meridian

14 July 2011

TPAG Transmission Pricing Discussion Paper

Meridian submission to TPAG on Transmission pricing discussion paper

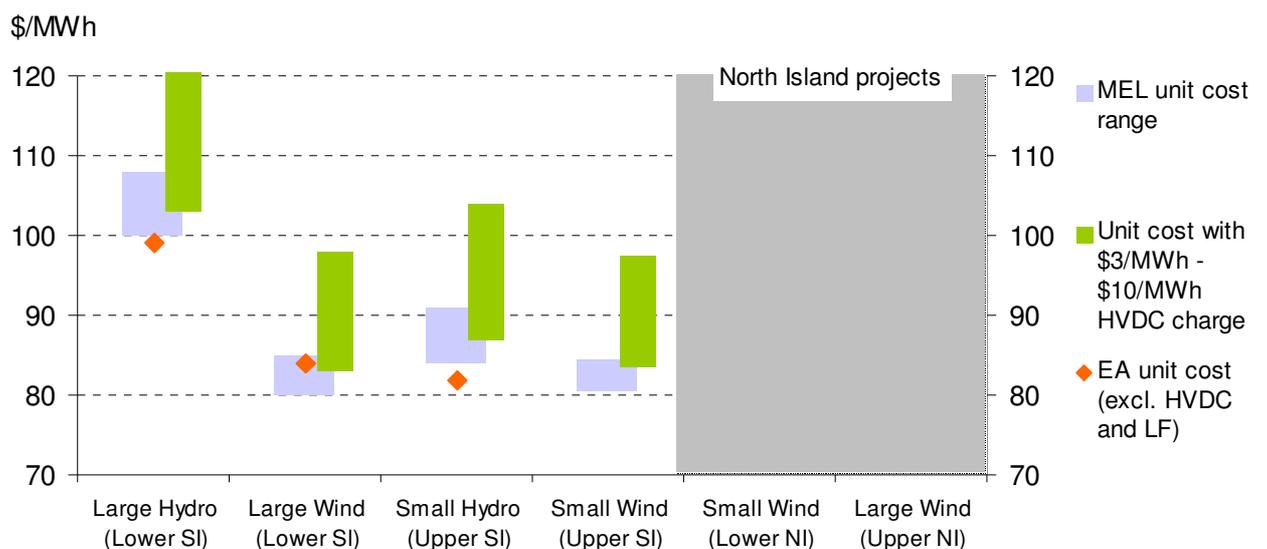
The analysis conducted by TPAG indicates that there is a clear and material cost associated with the current HVDC charge. An NPV over 30 years of 11-96m warrants analysis of alternative cost allocation options. By comparison Meridian notes the estimated NPV over 30 years of the locational risk proposal is between 38-77million.
